**RE-EVALUATION**  
of the  
**Environmental Assessment**  
**US 95 Northwest – Washington Avenue to Kyle Canyon**  
**Clark County, Nevada**

**FHWA-NV-EA 07.01**

December – 2012

**Project Name:** US 95 Northwest – Washington Avenue to Kyle Canyon Road

**Figure 1-9a Eliminate Sound Wall S635**

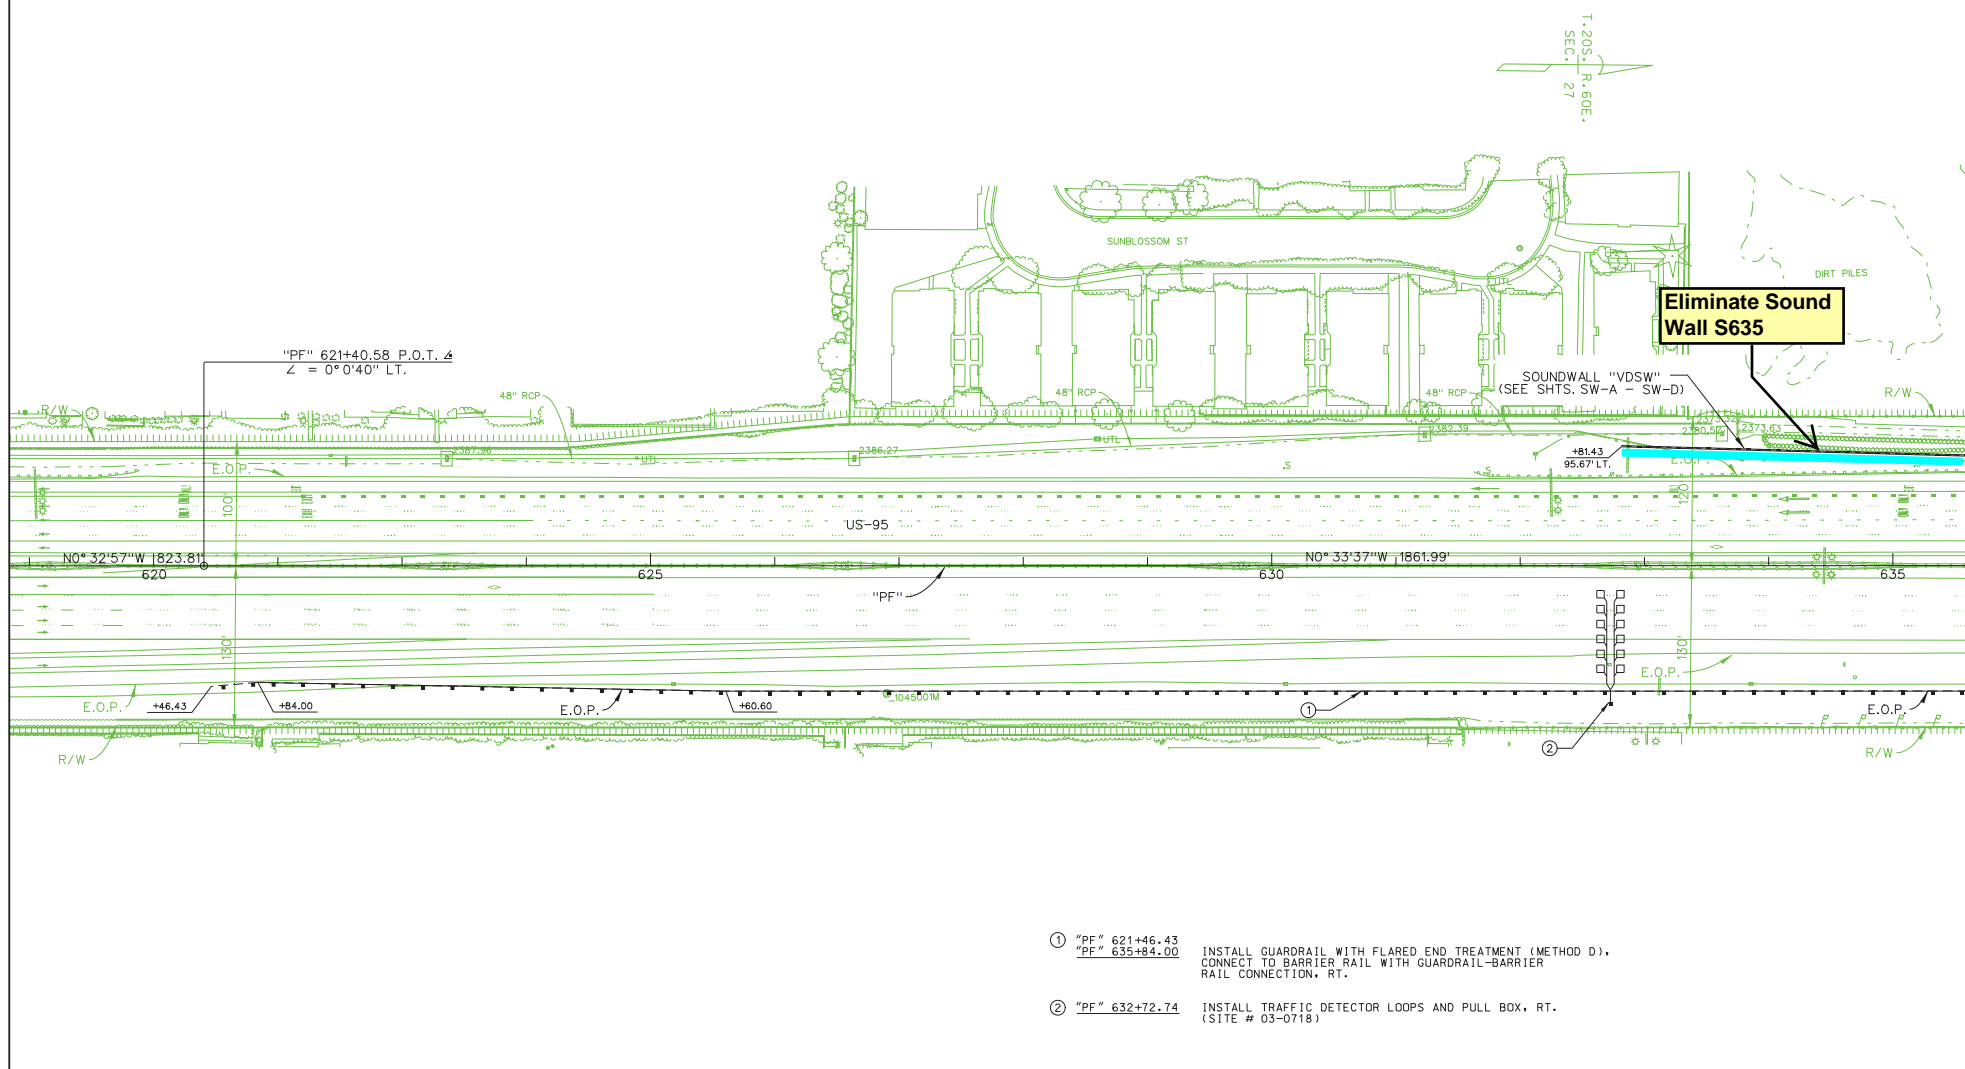
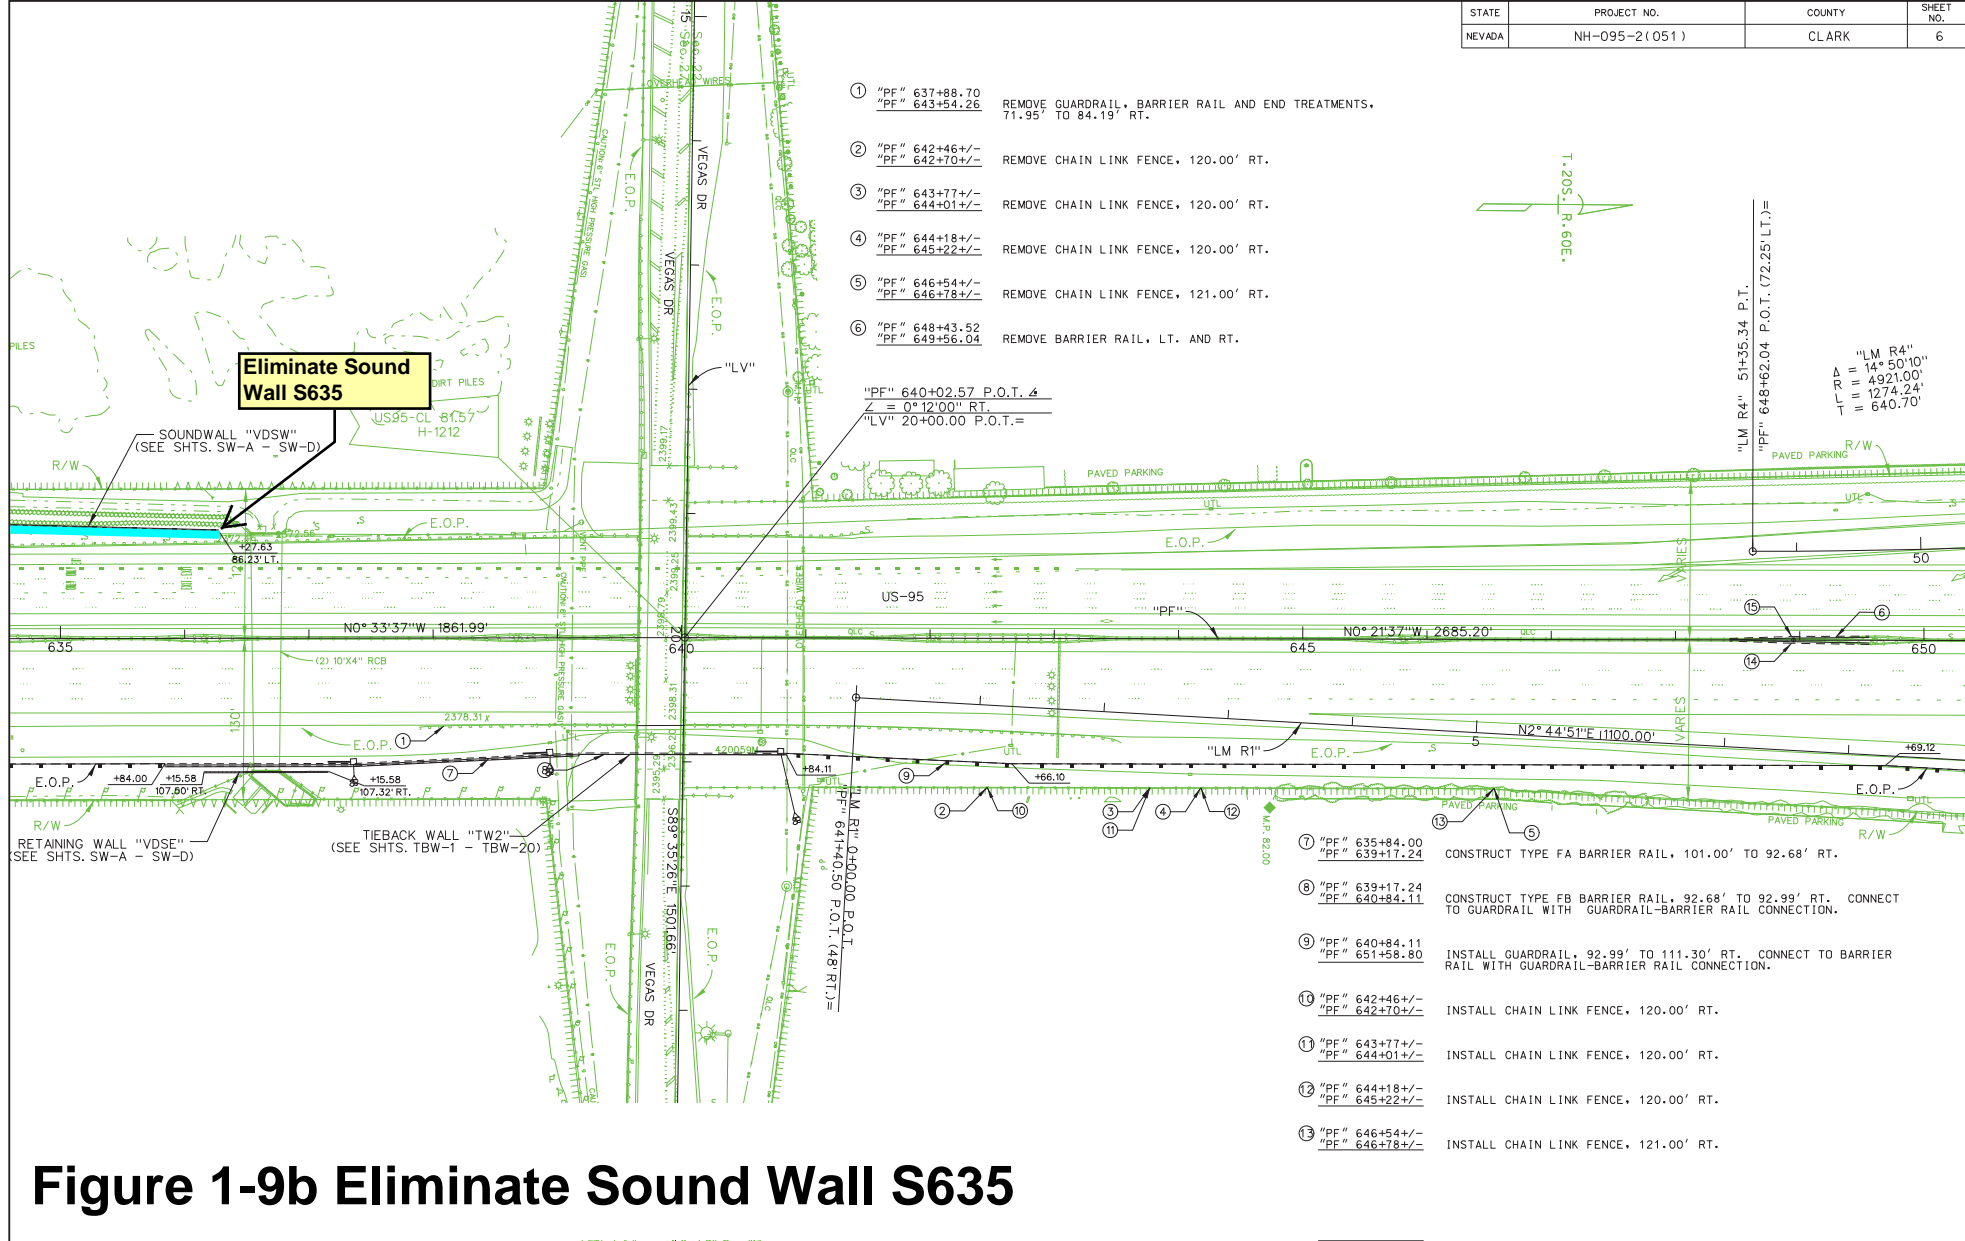
The proposed sound wall (S635) was located on the southwest corner of Vegas Drive and US 95 (*Figures 1-9a and 1-9b*). This sound wall provided a traffic noise abatement measure to an undeveloped and unpermitted, commercial-zoned property (Activity Category F). The land owner requested NDOT not construct this sound wall. It was re-evaluated to determine if this wall meets policy guidelines. Based on further review the sound wall does not meet the requirements for FHWA and NDOT traffic noise policy guidelines. Land identified as Activity Category F requires no further analysis or consideration of mitigation. In addition, since a sound wall already exists in the area, a traffic noise impact was not identified at the residential development south of the commercial property (Activity Category B).

**Figure 1-10b Eliminate Sound Wall S889**

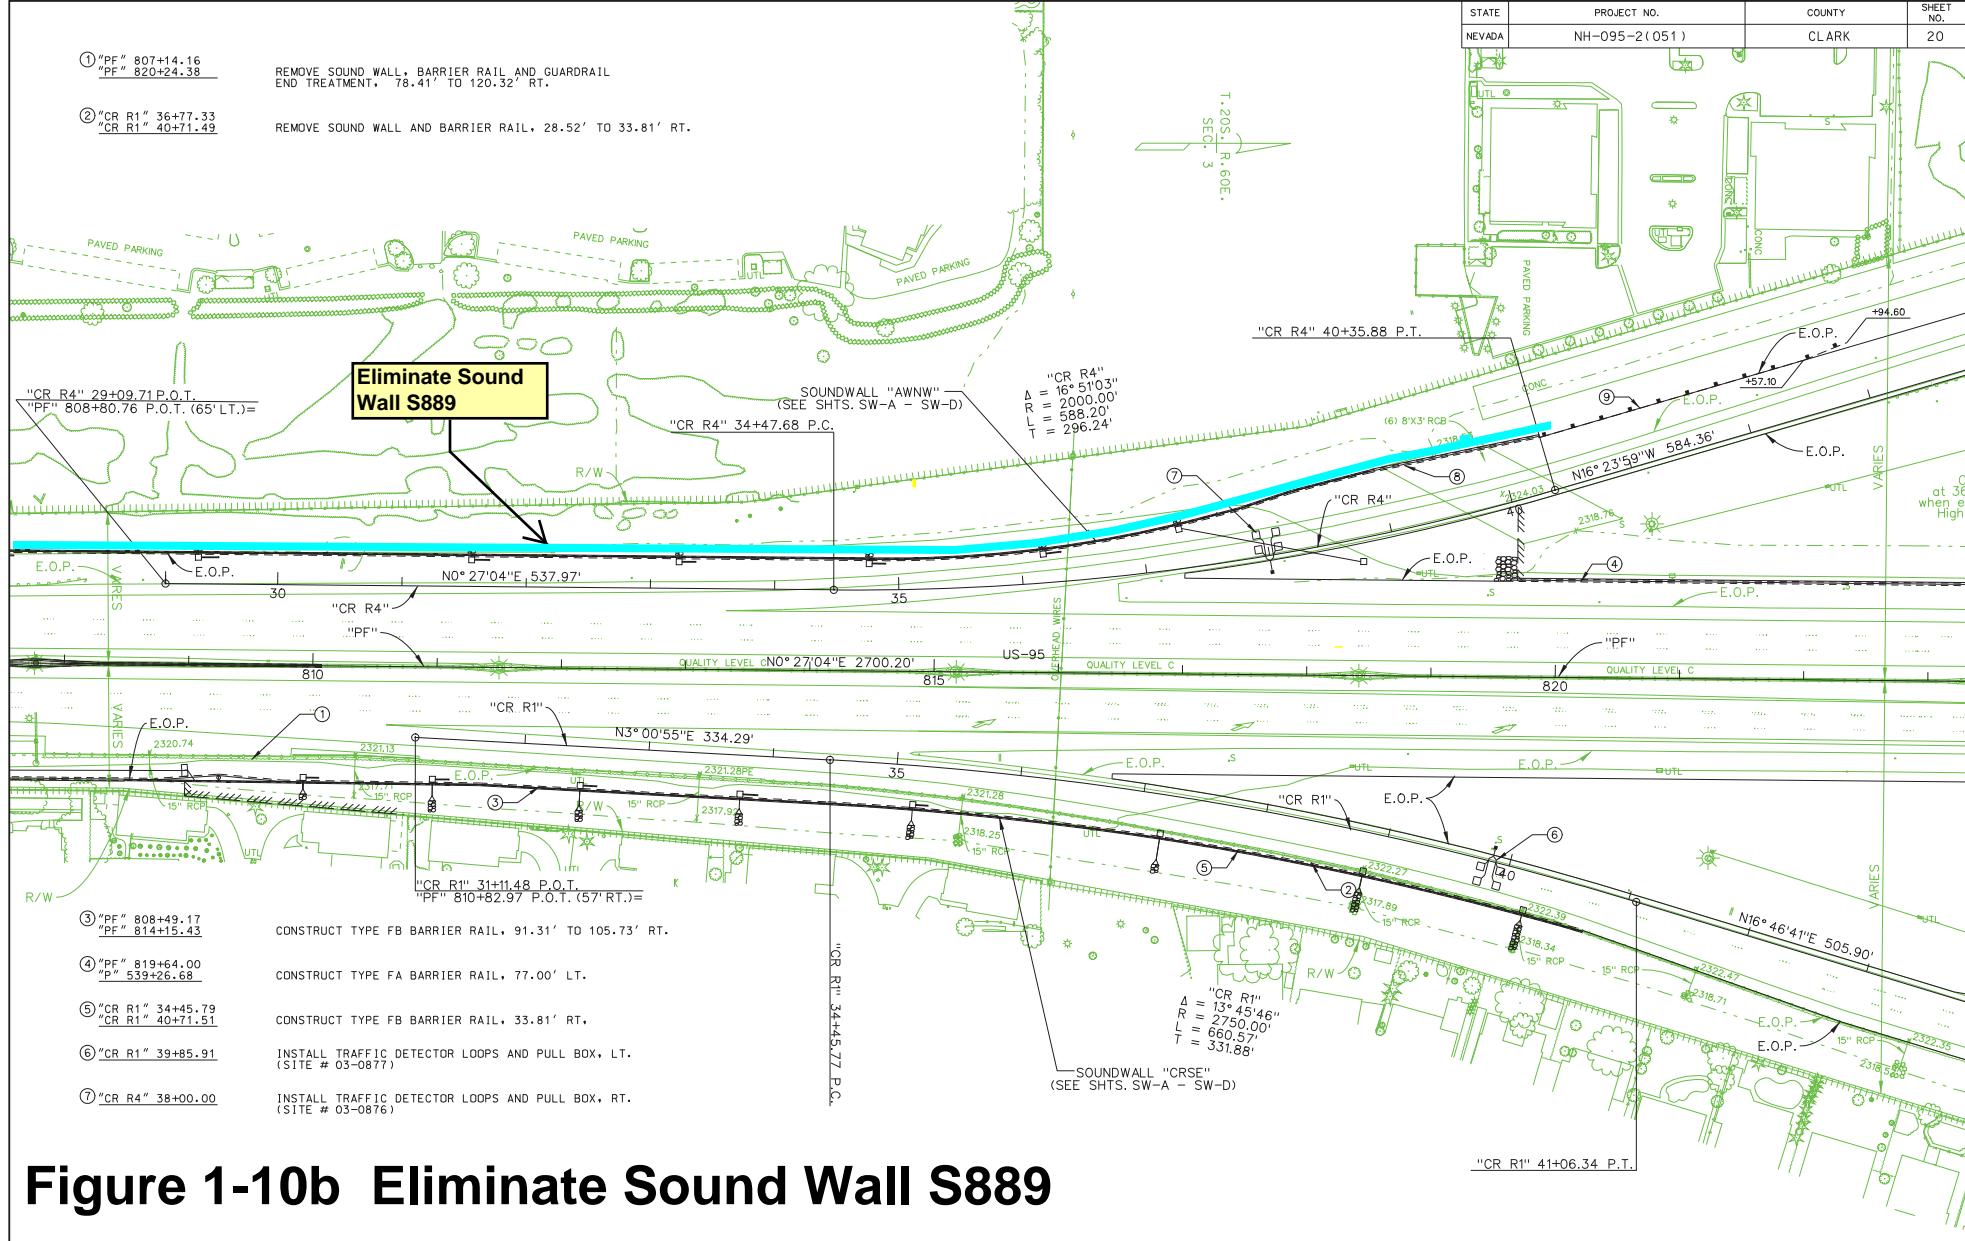
The proposed sound wall (S889) is located between W. Alexander Road and Craig Road on the west side of US 95 (*Figures 1-10a and 1-10b*). It was to provide a traffic noise abatement measure for the existing multi-family residential development (Activity Category B). The sole property owner associated with sound wall S889 requested the wall be deleted and signed an agreement with NDOT. The agreement releases NDOT of all claims related to noise, dust,
